CITY OF ALBUQUERQUE

- RE: Lot 38 Block 8, Unit 22 Volcano Cliffs
~~4471~~ ~~6435~~ Picardia Pl NW
OK Grading and Drainage Plan
Engineers Stamp Date 4/9/15 (D10D003E38)

GRADING & DRAINAGE PLAN
~~6435~~ ⁶⁴³¹ Picardia Place NW
 LOTS 38, BLOCK 8, UNIT 22 VCS

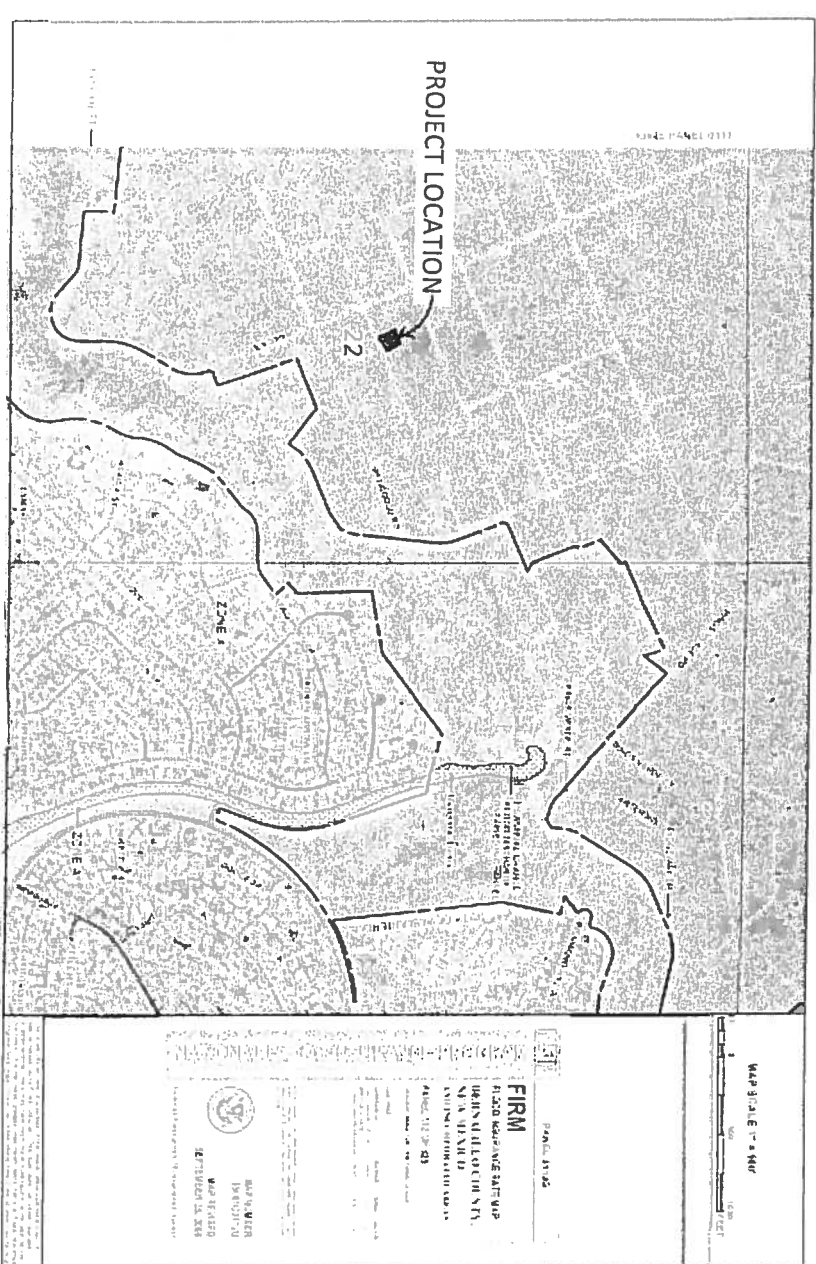
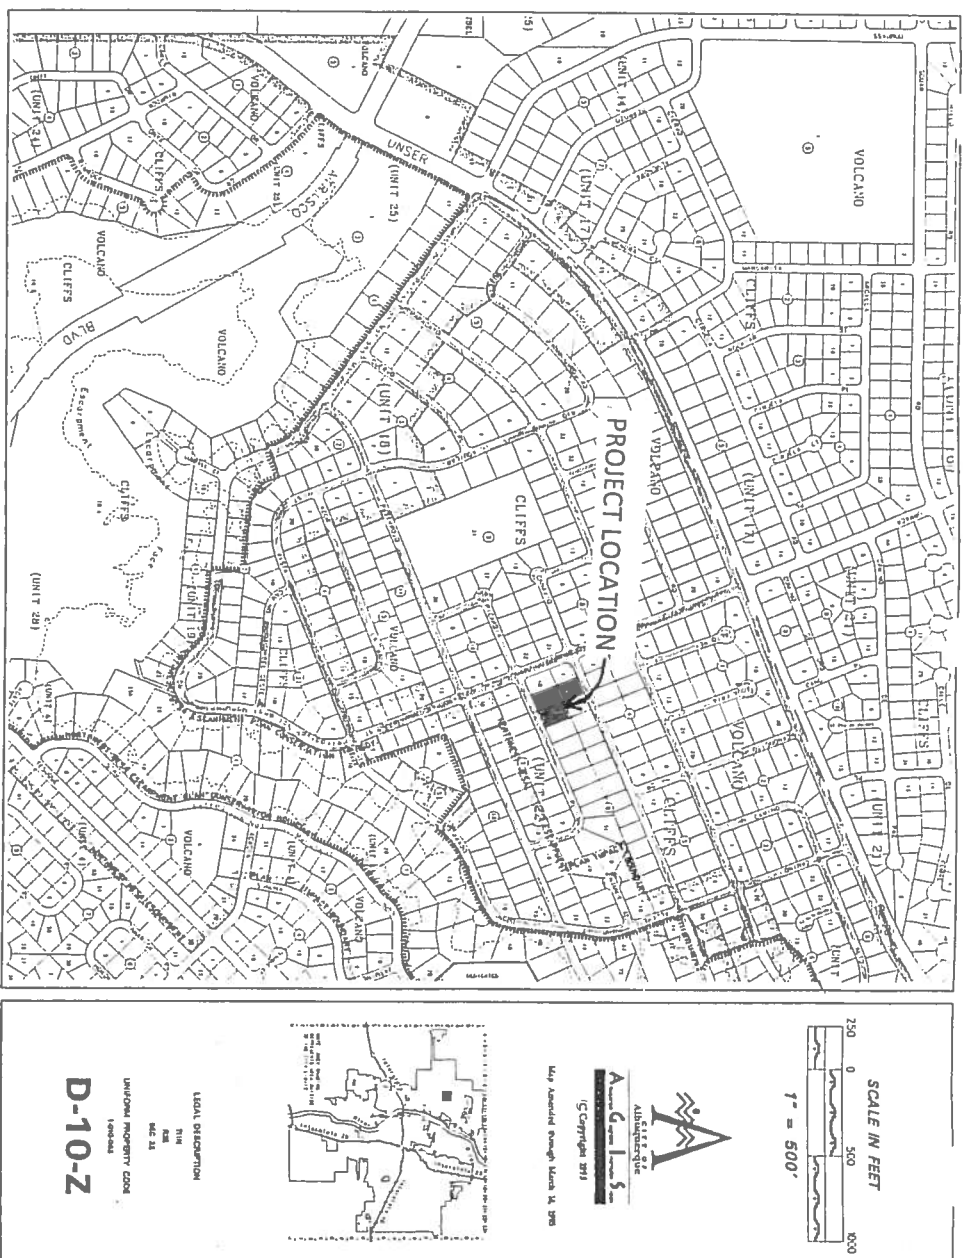
Based upon the information provided in your submittal received 4/9/2015, this plan is approved for Grading Permit and Building Permit.

Please attach a copy of this approved plan to the construction sets in the permitting process prior to sign-off by Hydrology.

Prior to Certificate of Occupancy release, Engineer Certification per the DPM checklist will be required.
